# New Church and Hall Christ the King Catholic Church (Diocese of Lake Charles)

### **ADDENDUM NO. 1**

PROJECT: New Church and Hall Christ the King Catholic Church

Hoffpauir Studio Project No: 23.033

L101

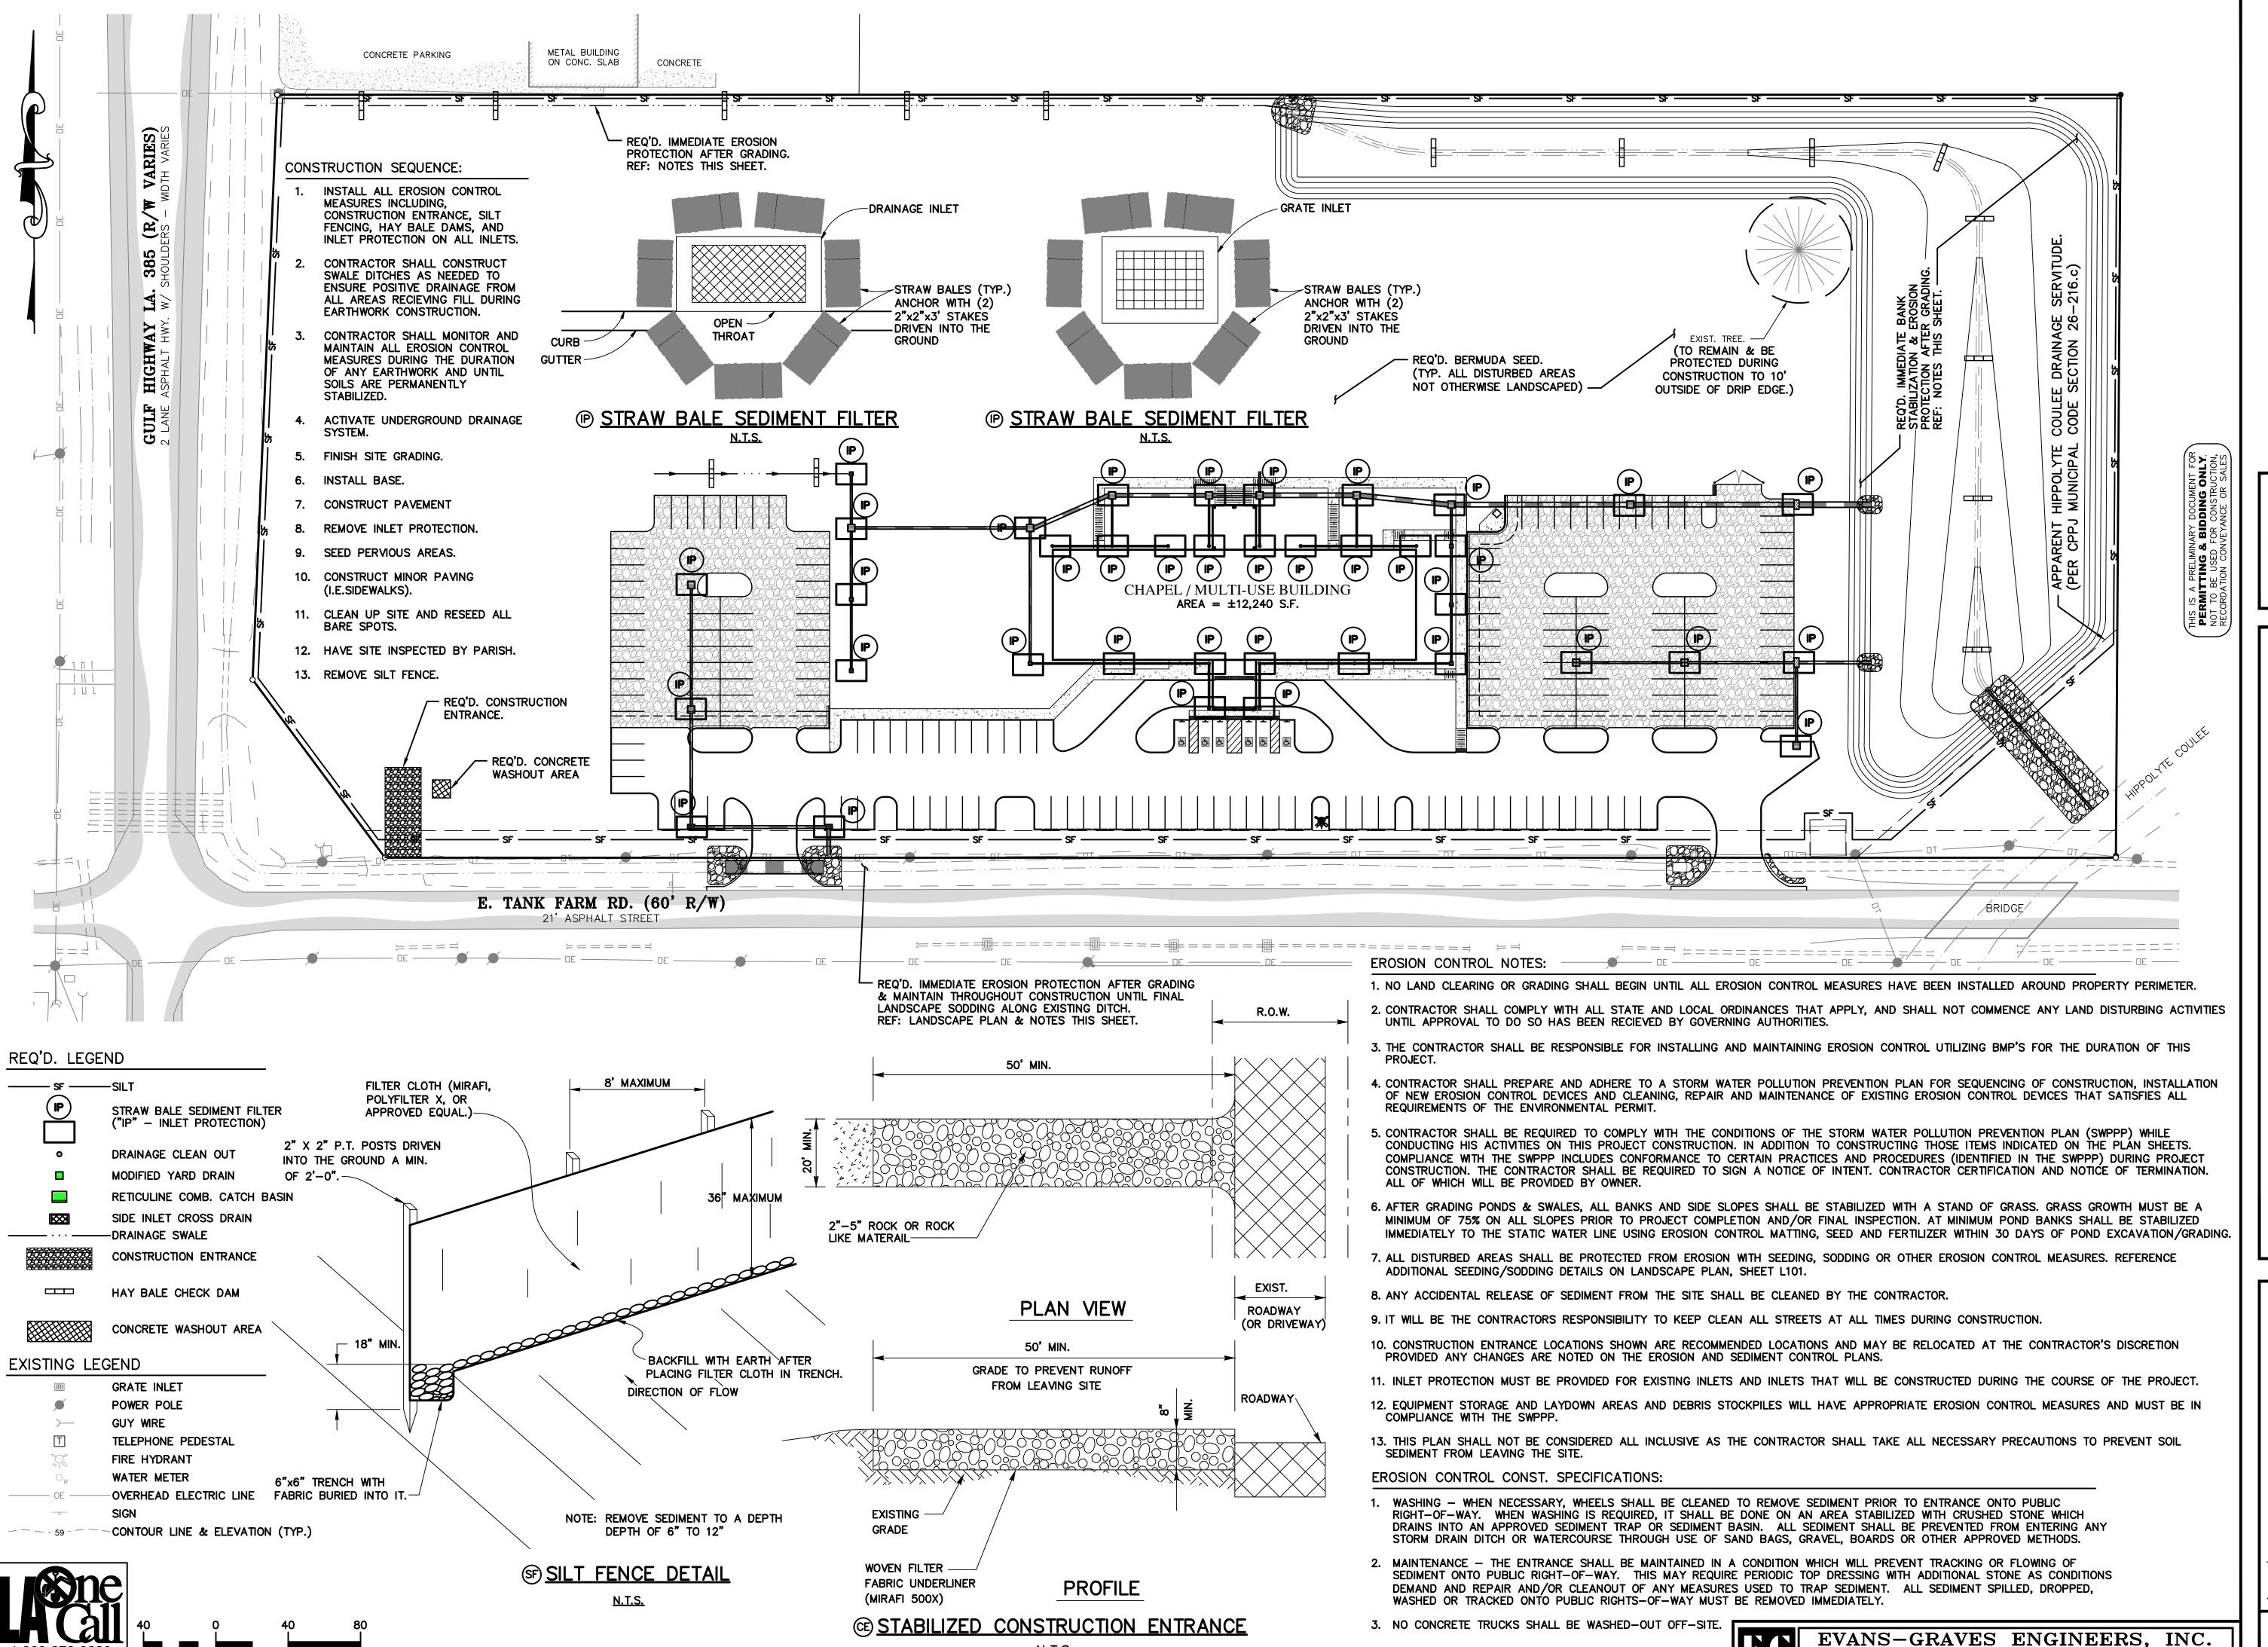
- 16. The entire site shall be filled and graded per plan, including mitigation/detention pond and all fill areas. Ref. sheets C103 and Mit 101-103
- 17. All disturbed/graded areas on the site outside of landscaped/sodded areas shall be seeded for future grass growth and generally long term erosion protection. Drainage swales and ditch/pond banks and side slopes shall be protected for immediate erosion prevention and protection with soil protection blanket, including erosion control matting and/or seeding/hydroseeding as necessary for field/construction conditions require. Ref. Erosion Control Sheet C108 Non-paved areas adjacent to building/parking shall be sodded with common Bermuda sod within limits as depicted on revised Landscape Plan Sheet LS01. Replace L101 and C108
